# OBJECTION

SWALCLIFFE PARK EQUESTRIAN

To develop two sand schools with  
parking, and change of use of land  
from agricultural to equestrian

CDC Ref 13/01128

**Fig 10** showing Applicants' Visual Envelope Plan, overmarked in faded blue with enlarged Visual Envelope for the Top and 28-Day Fields. The pink area indicates an estimated VE for the Stourwell Barn Anaerobic Digester (labelled AD site).

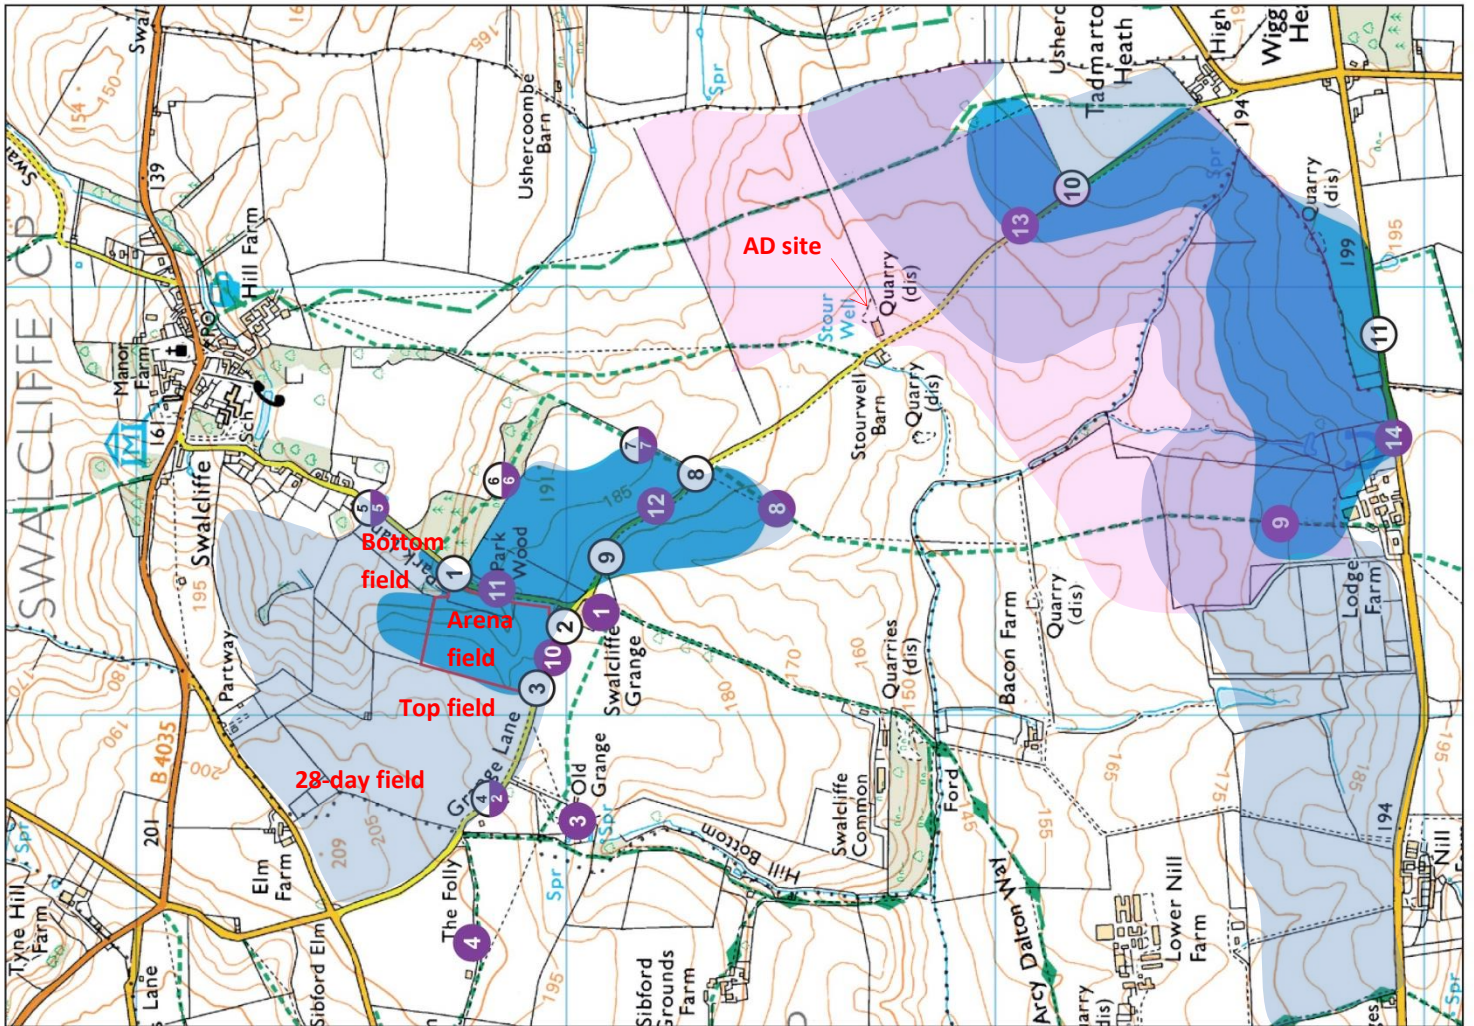
- 4.3. The extent of intervisibility with the surrounding landscape of the Arena Field illustrated on the Applicants' LVIA Plan 4 is not disputed. However it only deals with the Arena Field and does not take account of the whole Application Site. **Fig. 10** takes Plan 4 and modifies the Visual Envelope (VE) to include an estimate of land area with views of the larger Application Site.
- 4.4. This only claims to be an estimated VE area, and has therefore erred on the cautious side. What cannot be in doubt though is the substantial increase in VE, and the additional potential public vantage points from which views of the 28-Day and Top Fields are visible.

- 4.16. Many of these views are from the same paths and roads from which the Swalcliffe Park Equestrian site is also visible, in fact as indicated on **Fig 10** the two developments would be visible together across quite a wide area of shared Visual Envelope.
